SERVICE BULLETIN

SB98.14

Machines/Models: AB46 Bi-Energy

PURPOSE: Isolate 12 volt circuit from accidental engagement.

Figure 1

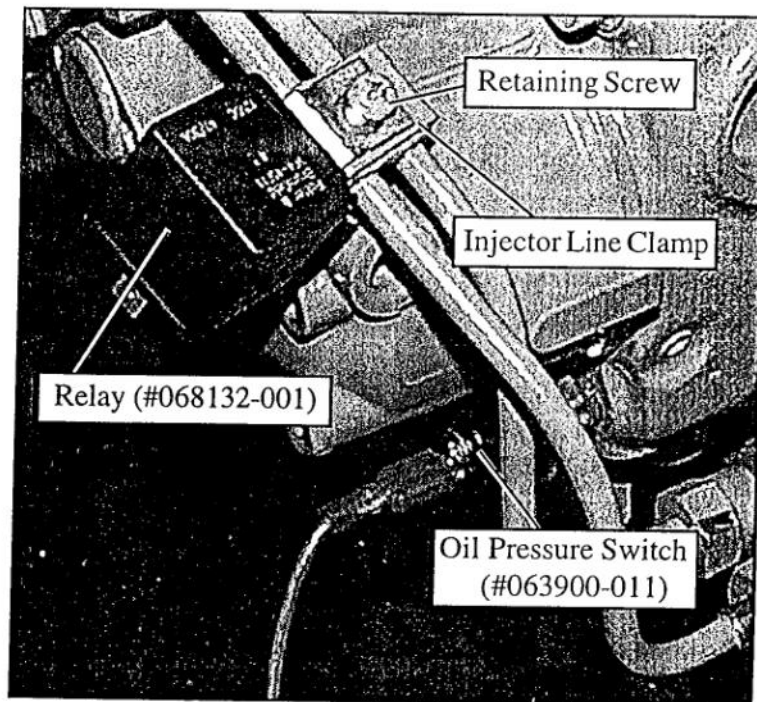
1. Disconnect ground cable from 12 volt battery.
2. Remove injector line clamp retaining screw (Figure.1), position Relay (#068132-001) on injector line clamp and install retaining screw.

3. Remove original Oil Pressure Switch and discard.
4. Install supplied Oil Pressure Switch (#063900-011).
5. Crimp to each end of supplied Orange wire (#029453-099) Push Terminals (#029616-002).

6. Connect one end of wire to the Oil Pressure Switch, the other end to previously installed Relay, terminal #85.
7. Locate Deutsch connector (connector with 4 wires secured to battery cables).

8. Cut Org./Blk. wire 4 inches from connector.
9. Crimp Push Terminal (#029616-002) on engine side of wire, connect Push Terminal to Relay, terminal #87.

10. Crimp Butt Connector (#29620-002) to previously cut Org./Blk. wire, connector side. Crimp supplied Org./Blk. wire (#029472-099) to Butt Connector, crimp Push Connector (#029616-002) to other end. Connect Push Terminal to Relay, terminal #86.

11. Crimp Ring Terminal (#029601-015) to supplied Red Wire (#029454-099). Remove from starter solenoid positive battery cable retaining nut. Install Ring Terminal on solenoid post, reinstall retaining nut.
12. Crimp Push Terminal (#029616-002) to other end of wire. Connect Push Terminal to Relay, terminal #30.
13. Secure wires properly via supplied Plastic Ties.
14. Reconnect ground cable to 12 volt battery.
15. To verify modification has been performed successfully, have the operator attempt to start engine. Verify throttle solenoid pulls in after a momentary delay, (the engine must develop oil pressure before accessory functions will be engaged). If engine does not perform as described above, contact UpRight Technical Support.

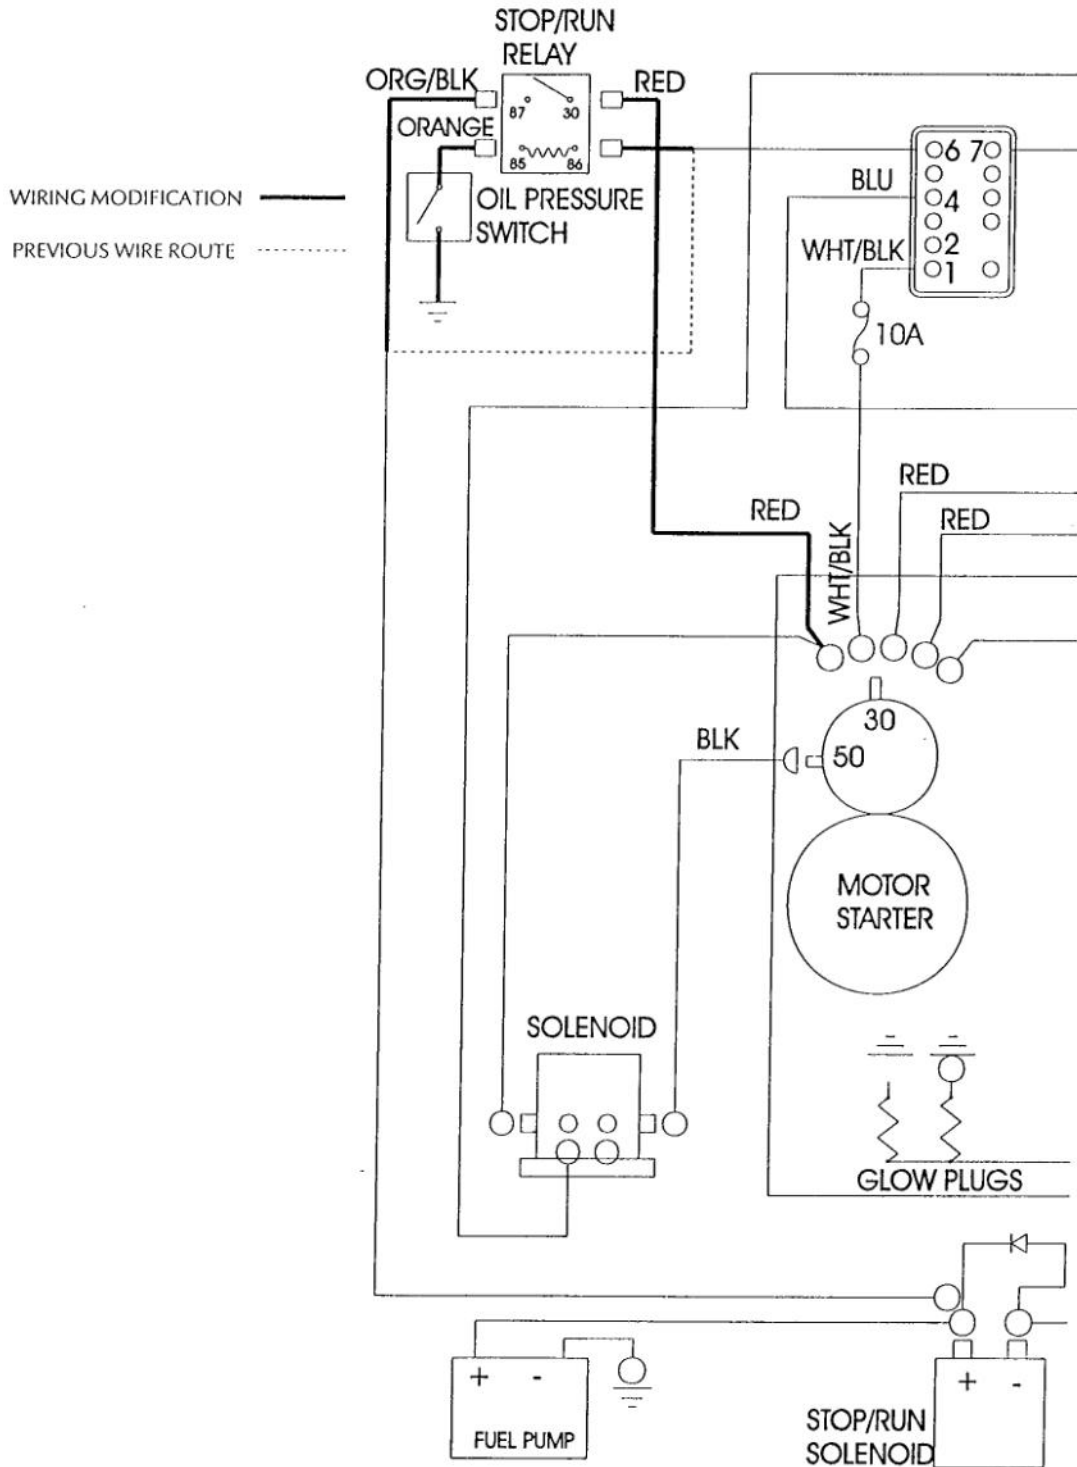
PROCEDURE: Read all instructions thoroughly and refer to figures 1 and 2 before starting.
